**June 3, 2021
6:30 PM**

- A. ZCU-21-3 Outdoor Storage Conditional Use Permit to Allow T.A. Schifsky & Sons, Inc. to Install Three (3) New Silos and a Scale.

Date: 5/28/2021
To: Planning Commissioners
From: Eric Zweber, AICP, City Planner
CC: Scott Duddeck, City Manager
Re: Outdoor Storage Conditional Use Permit for Three (3) New Silos and a Scale at T.A. Schifsky & Sons (2310 Highway 36 E)

Engineering Comments:

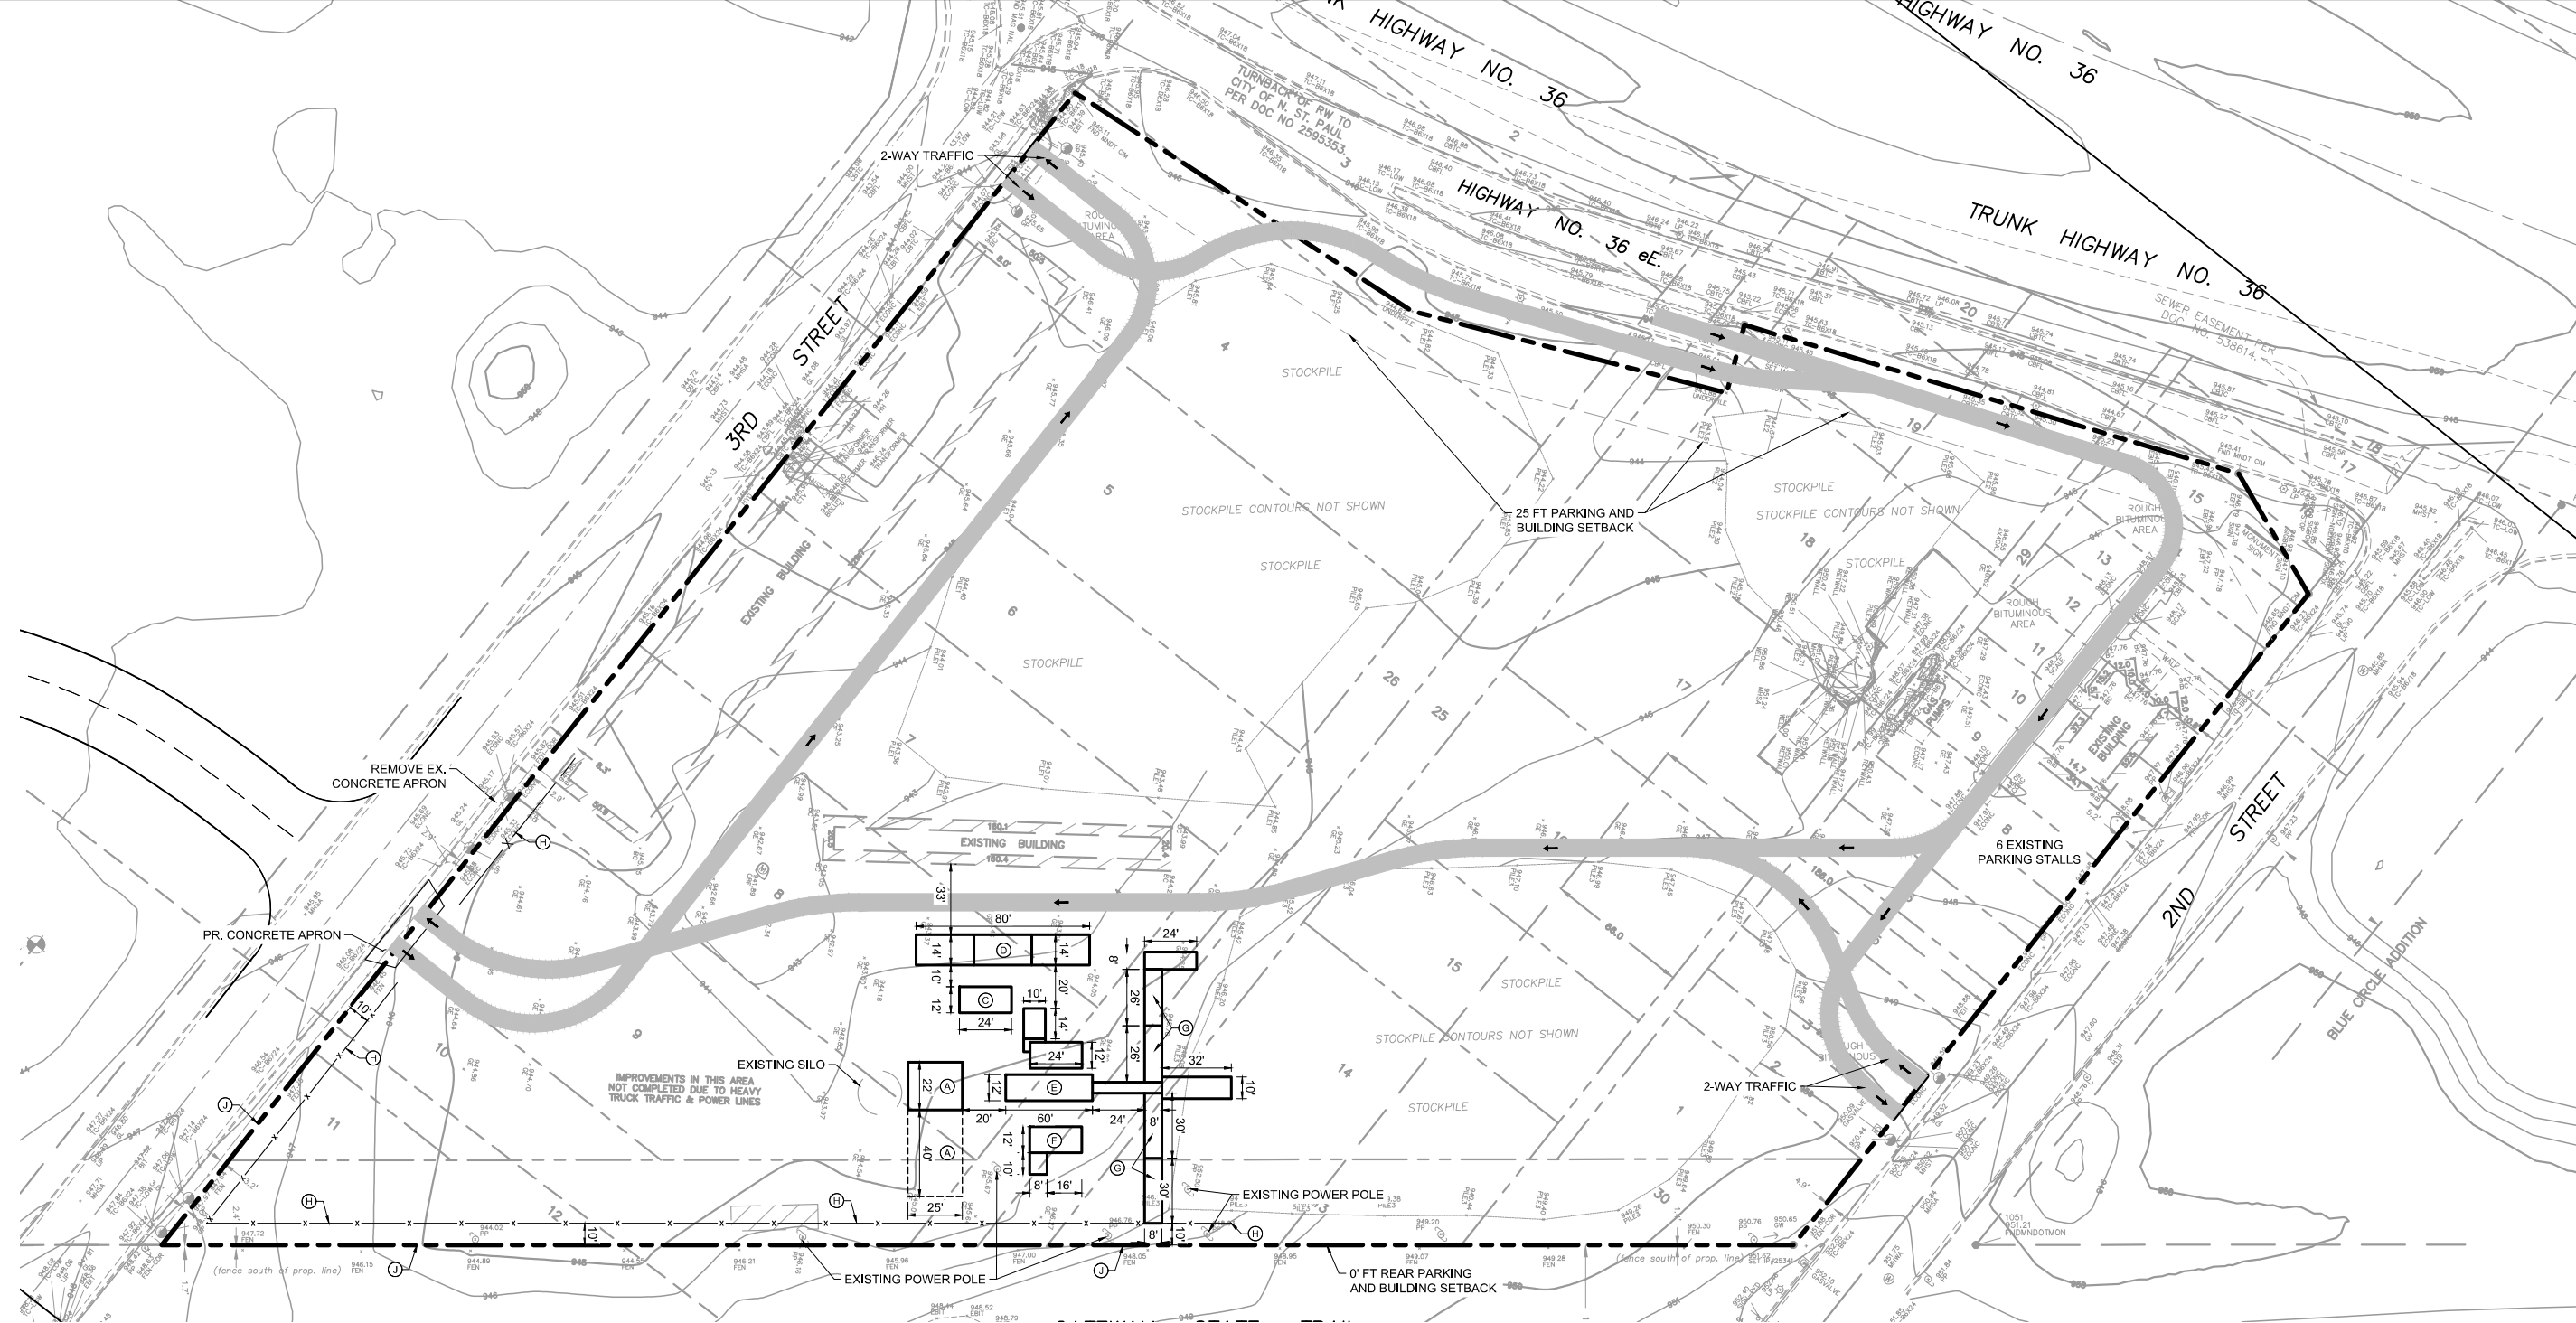
The City Engineer has preliminarily reviewed the application. The Engineering concerns are included in the proposed conditions of approval and will be reviewed during the building permit process.

1. Revised set of plans shall be submitted prior to building permit issuance for review addressing comments provided and incorporating any recommended comments as acceptable and necessary.

2. The applicant shall update their site plan to verify paved surfaces at each entrance to minimize sediment tracking on city streets. The failed concrete commercial driveway entrance at the south entrance off 3rd Street shall be replaced with a new commercial apron meeting city standards.

3. The applicant is responsible for and shall provide copies of all applicable permitting for the project prior to grading permit (mass grading) and/or building permit issuance, including but not limited to RWMWD and Minnesota Pollution Control Agency (MPCA) NPDES stormwater construction, City Erosion and Sediment Control Plan, MPCA/Metropolitan Council sanitary sewer extension, and Minnesota Department of Health watermain extension permits, as applicable.

Engineering Comments:

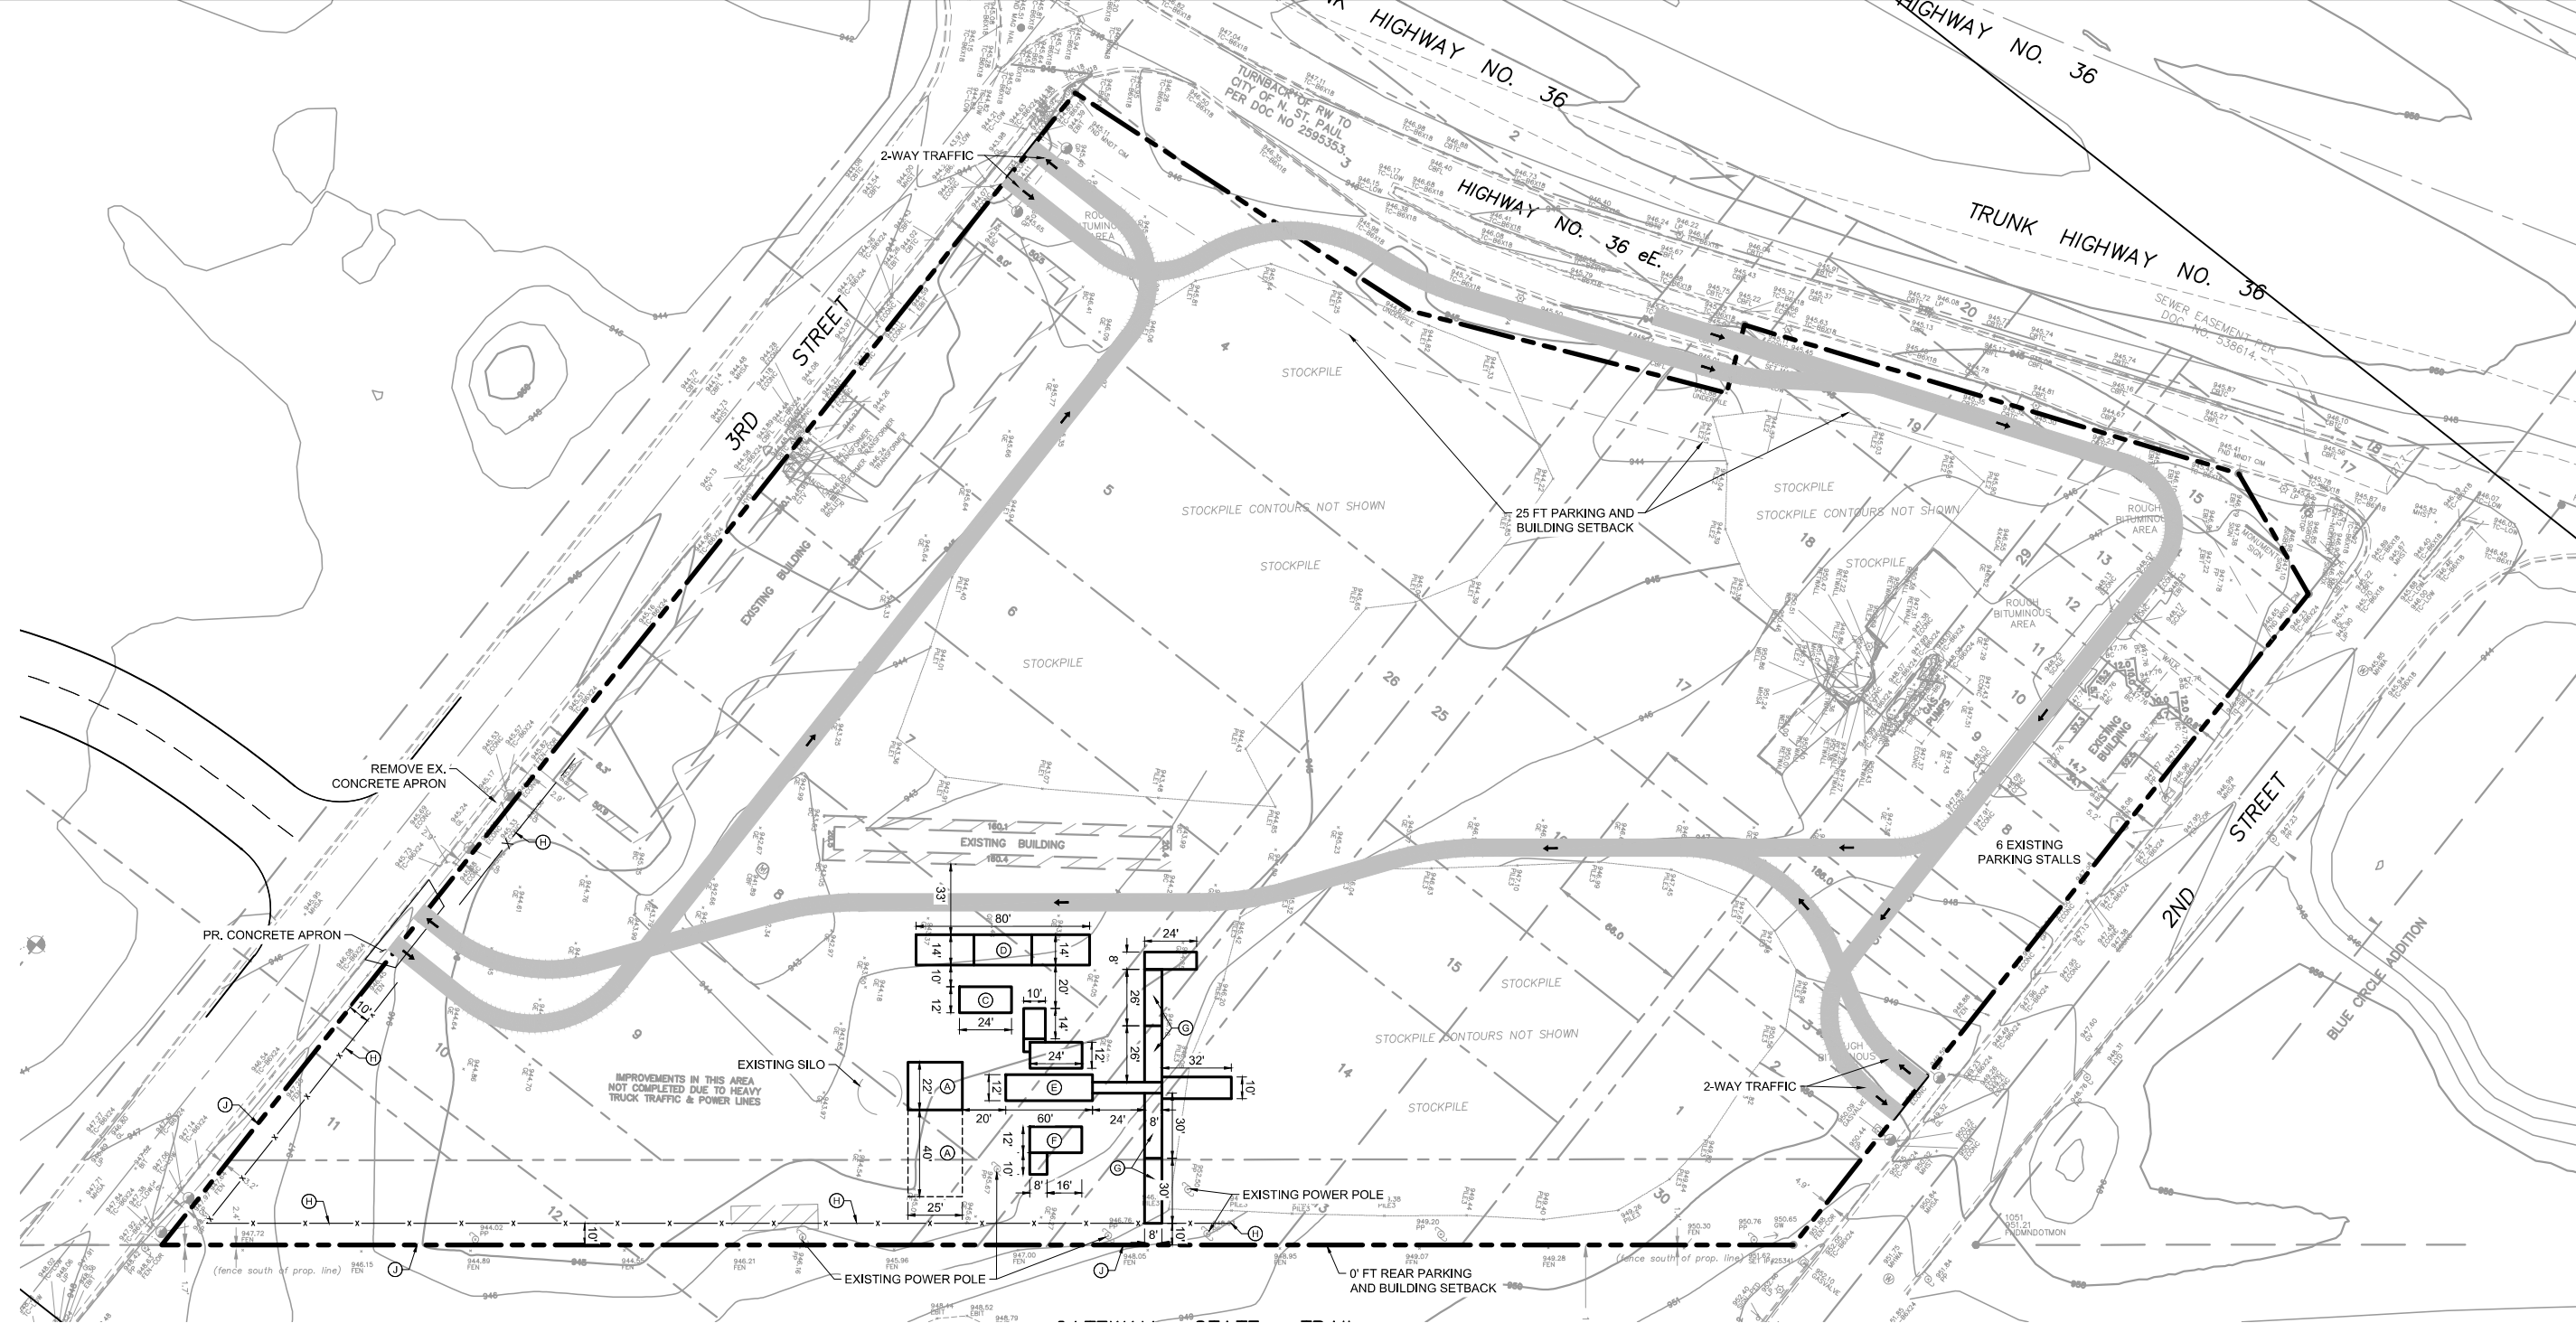
The City Engineer has preliminarily reviewed the application. The Engineering concerns are included in the proposed conditions of approval and will be reviewed during the building permit process.

1. Revised set of plans shall be submitted prior to building permit issuance for review addressing comments provided and incorporating any recommended comments as acceptable and necessary.

2. The applicant shall update their site plan to verify paved surfaces at each entrance to minimize sediment tracking on city streets. The failed concrete commercial driveway entrance at the south entrance off 3rd Street shall be replaced with a new commercial apron meeting city standards.

3. The applicant is responsible for and shall provide copies of all applicable permitting for the project prior to grading permit (mass grading) and/or building permit issuance, including but not limited to RWMWD and Minnesota Pollution Control Agency (MPCA) NPDES stormwater construction, City Erosion and Sediment Control Plan, MPCA/Metropolitan Council sanitary sewer extension, and Minnesota Department of Health watermain extension permits, as applicable.
